**Commonwealth Edison**

Subject: Byron Generating Station Units 1 and 2  
Braidwood Generating Station Units 1 and 2  
Fire Protection  
NRC Docket Nos. 50-454 and 50-455

Responses to 18 NRC Concerns  
Raided During the July 12-15, 1983

RESPONSES TO FIRE PROTECTION SITE AUDIT CONCERNS

REVISIONS			BYRON N.P.S., UNITS I AND II COMMONWEALTH EDISON CO.		
NO.	DATE	BY	TCO-003 HIGH DENSITY SILICONE ELASTOMER FOR THIN FLOORS OR WALLS (LESS THAN 12" THK.)		
1			DRAWN BY	GJJ	SCALE NA
2			CHK'D	6/6	DATE 8-17-83
3			TRACED		APP'D 6/6
4					MATERIAL TCO-003 H.D.E.
5					DRAWING NO. BY-E-14

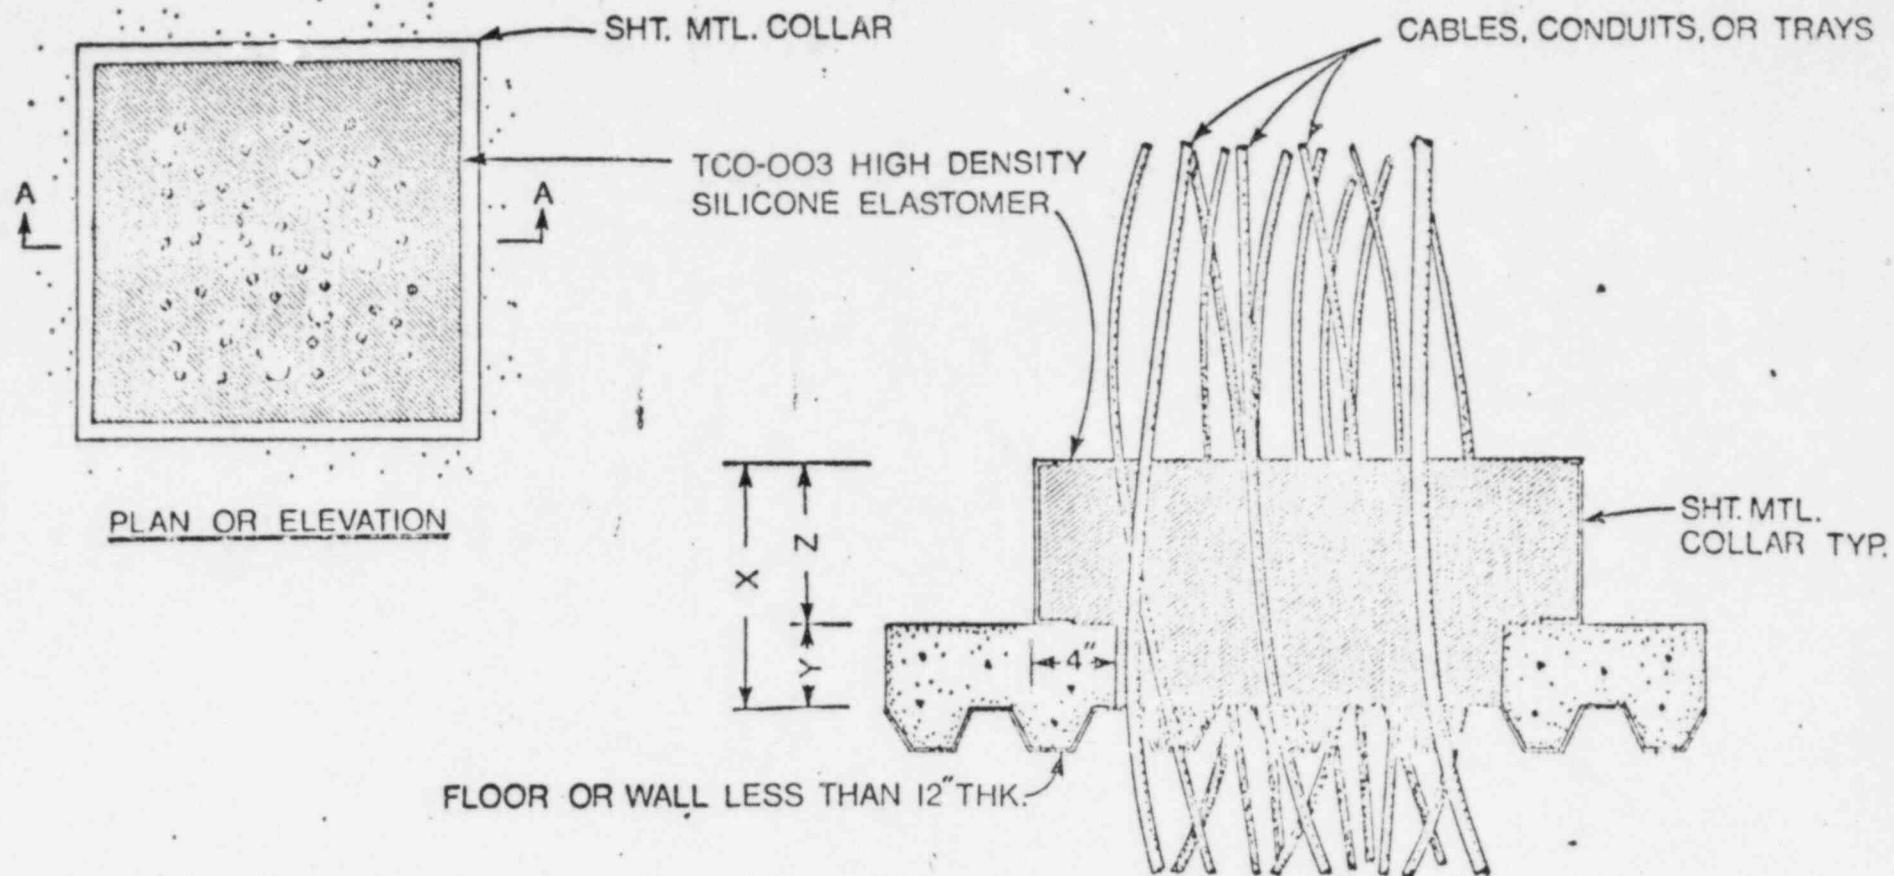
The following features of the fire protection program were observed to be incomplete:

- A) The installation of penetration seals in fire walls and fire rated floor/ceiling assemblies.
- B) The provisions of seismic supports for the Hydrogen supply piping routed through the Auxiliary Building.
- C) The installation of fire proofing for steel structural elements.
- D) The installation of fire hose nozzles, hose houses and hose-house fire fighting equipment.
- E) The third repeater for the plant emergency communications network.
- F) The O.S. Y-type sectional control valve at the discharge outlet for the fire pumps to avoid the necessity of shutting off one fire pump in order to test the other.

The applicant should verify that these features of the fire protection program will be completed by fuel load.

- A) All required penetration seals for fire walls and fire rated floor/ceiling assemblies will be installed by fuel load.
- B) It is the applicants practice to seismically support all piping in Category I structures, including Category II piping. A review of the hydrogen piping reveals that it is in fact seismically supported in the auxiliary building.
- C) All structural steel elements requiring fire proofing will be coated by fuel load.
- D) All fire hose nozzles, hose houses, and hose house fire fighting equipment will be installed and available for use prior to fuel load.
- E) The third radio repeater for the plant communications network has been installed.
- F) The control valve in the discharge header of the fire pumps has been installed.

BYRON / BRAIDWOOD STATION  
 FIRE PROTECTION REPORT  
 FIGURE 23-8  
 MAIN FLOOR AT EL 451'-0"  
 (SHEET 2 OF 4)

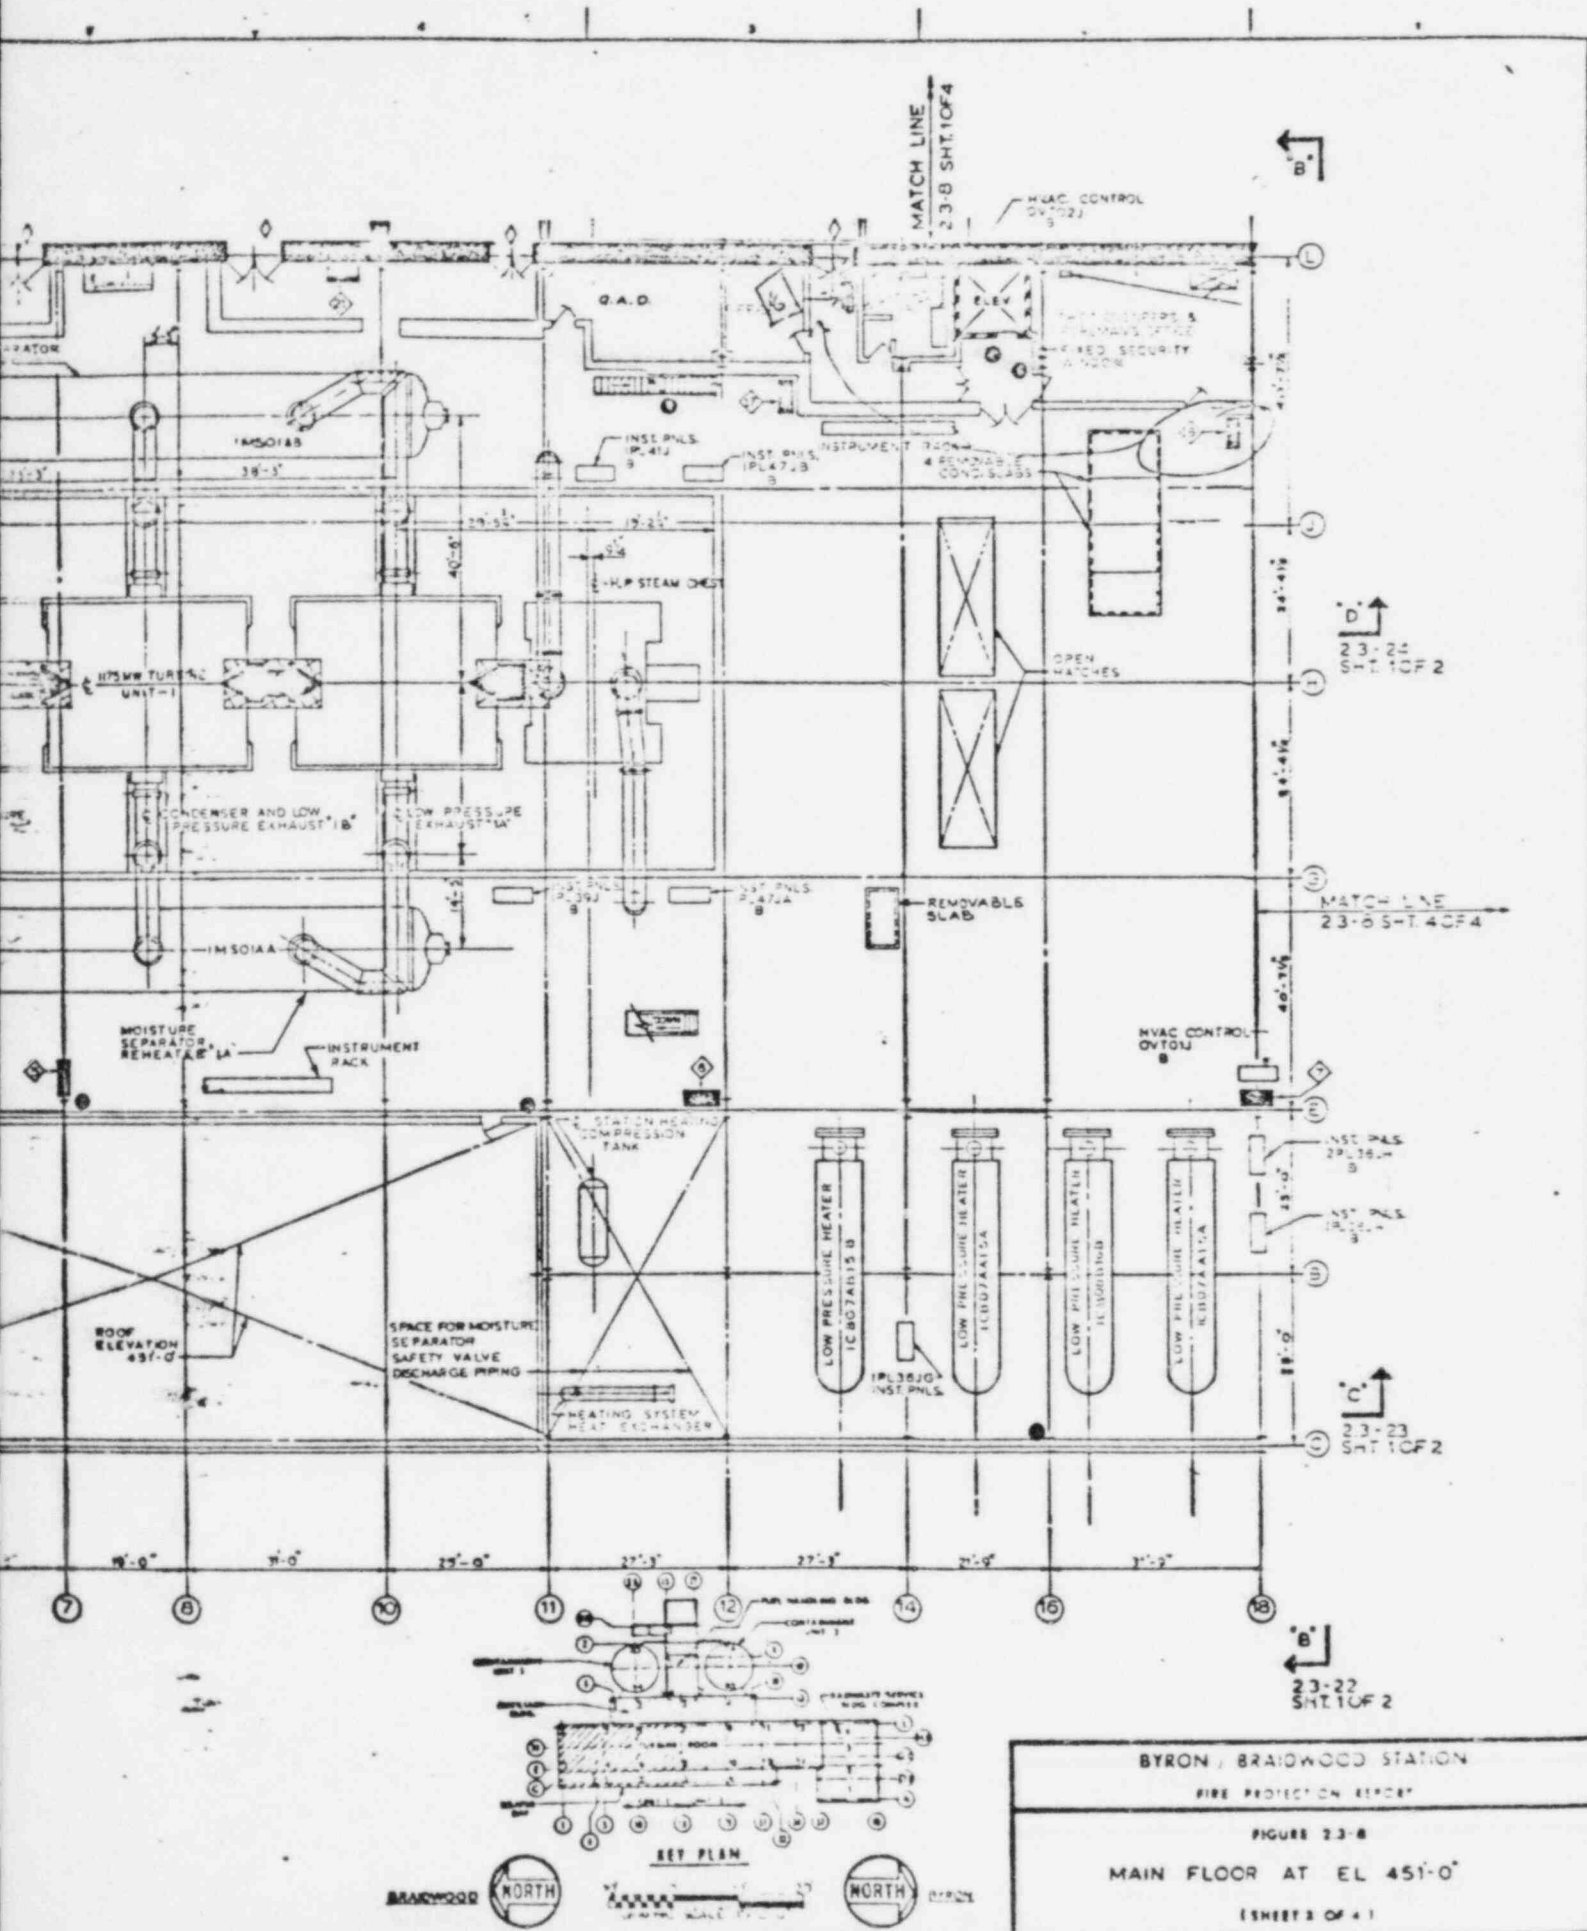
To comply with Section C.6.c of BTP CMEB 9.5.1, interior manual hose stations should be installed so as to be able to reach any location that contains, or could present a fire exposure hazard to safety related equipment with at least one effective hose stream. We observed that because of the present location of manual hose stations, it may not be possible to reach all areas of the computer room and cable riser area on elevation 451 feet. The applicant should conduct a hose stretch test to verify the adequacy of the existing design.

We also observed that because of congested conditions in certain plant areas, such as the cable spreading rooms, it may not be possible to utilize existing manual hose stations because of the inability to fully deploy the woven-jacketed fire hose. In such areas, to comply with Section C.6.c of BTP CMEB 9.5.1, it will be necessary to replace the woven-jacketed hose with a hard rubber type.

The applicant agrees that the computer room and cable riser area on elevation 451'-0" cannot be reached by presently located hose stations. In order to alleviate this concern, hose station no. 16 will be relocated so that it is close enough to these rooms to reach them with an effective hose stream. The Fire Protection Report will be revised in a future amendment to include this change (Revised Fire Protection Report pages are attached).

The applicant also agrees that the use of the woven-jacket fire hose would present difficulties in the upper and lower cable spreading rooms. In these rooms, all of the existing woven-jacket fire hose will be replaced with a hard rubber type fire hose. No Fire Protection Report changes are required by this design change.

Fibrocode CT Gypsum Cement Seal with collar  
Detail "D1"

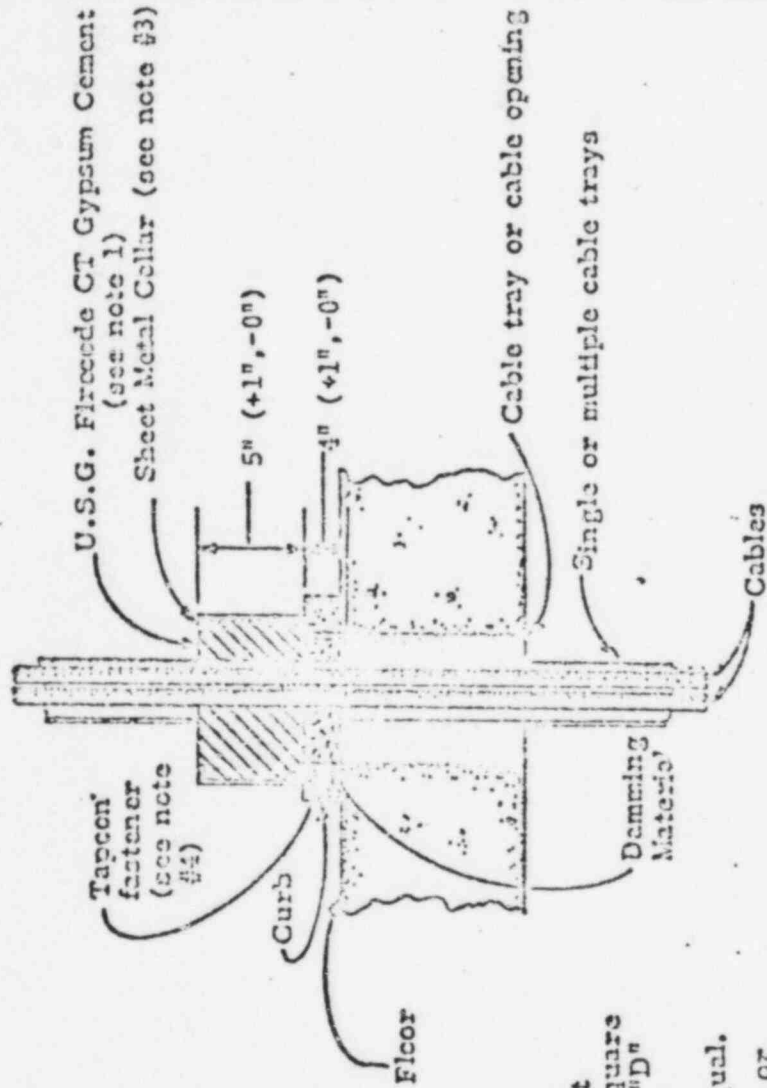
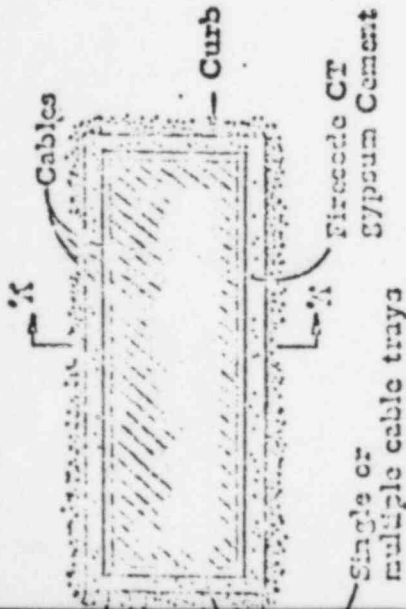
In the August 16, 1982 revision to the Fire Protection Report, the applicant committed to seal fire barrier penetrations with material having a fire resistance rating comparable to the ratings of fire walls and floor/ceiling assemblies. This necessitates that sealant material be installed to an appropriate depth consistent with its UL listing. We observed that RTV silicon sealant material was installed in the plant in thicknesses greater than the depth of the concrete floor slab. This configuration does not appear to be consistent with the listing of the material. We are concerned that this sealant material will not be able to withstand anticipated fire exposures. The applicant should verify that penetration seals featuring silicon foam, as installed in the plant, are equivalent to the structural assembly.

The sealant fire test reports for the different fire stop materials used in "electrical" openings in walls, floors, or ceilings address the amount of fire stop material required in order to meet the required fire ratings of these fire barriers. This information is transmitted to the installation contractor via drawings which give specific installation requirements for each opening requiring a fire stop. For openings where the thickness of the fire barrier is less than required thickness of the fire stop material, a detail has been shown on the installation drawings specifying how the required thickness is to be attained. The type of detail used for attaining a thickness of fire stop greater than the floor thickness is shown on drawing B1-E-0-5A (copy attached). The fire stop sealant test reports also address the installation of plugs in installed fire stops. For this testing an installed fire stop was drilled to make an opening and then resealed with the same fire stop material. The installation was subsequently exposed to fire tests.

The applicable test reports for the fire stop materials used in "electrical" openings in floors, walls, and ceilings at Byron/Braidwood are listed below. These test reports are currently under review to verify that the fire stops meet all applicable requirements.
